Well Name: WF FEDERAL 30	Well Location: T30N / R14W / SEC 30 / SESE / 36.780263 / -108.345468	County or Parish/State: SAN JUAN / NM
Well Number: 2	Type of Well: OTHER	Allottee or Tribe Name:
Lease Number: NMNM99003	Unit or CA Name:	Unit or CA Number:
US Well Number: 3004531307	Well Status: Gas Well Shut In	Operator: HILCORP ENERGY COMPANY

Type of Action: Plug and Abandonment

Attachment to notice of Intention to Abandon

BLM FLUID MINERALS P&A Geologic Report

PROPOSED P&A WELLBORE SCHEMATIC

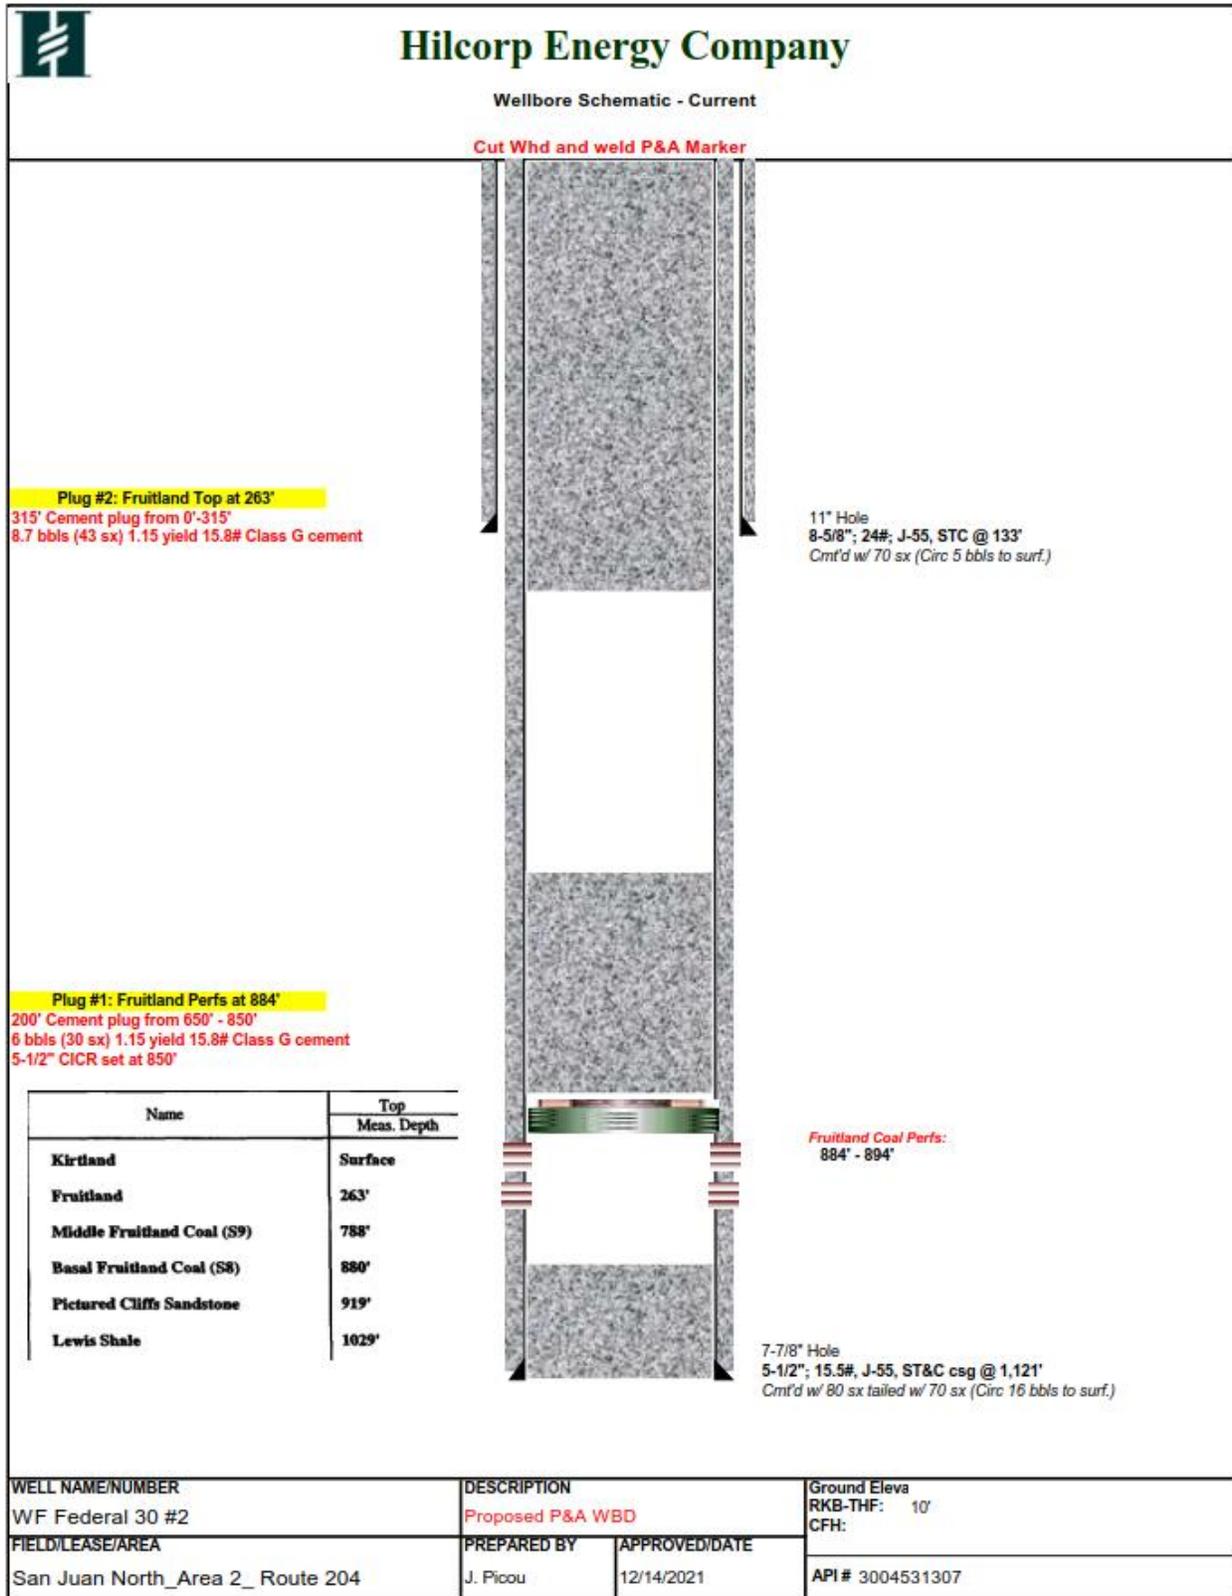
1. Plugging operations authorized are subject to the attached "General Requirements for Permanent Abandonment of Wells on Federal and Indian Lease."
2. The following modifications to your plugging program are to be made:
 - a) Add a plug, or cement below the retainer, to cover the Pictured Cliffs formation top at 919 feet.
 - b) Plug 1 (Fruitland): Bring the top of the plug up to 588 feet to cover BLM pick for the Fruitland formation top.
3. Farmington Office is to be notified at least 24 hours before the plugging operations commence at (505) 564-7750.

- BLM pick for the Fruitland formation top varies from Operator's pick.
- Add a plug, or pump cement below the retainer, to cover the Pictured Cliffs formation top at 919'.
- Bring the top of Plug #1 up to 588' to cover BLM pick for the Fruitland formation top.
- The plugs proposed in the P&A procedure, with recommended changes, will adequately protect any freshwater sands in this well bore.
- Fruitland coal perms 884' – 894'.
- Note: H₂S has not been reported in this well but has been reported in nearby wells to the north at concentrations up to 1000 PPM.
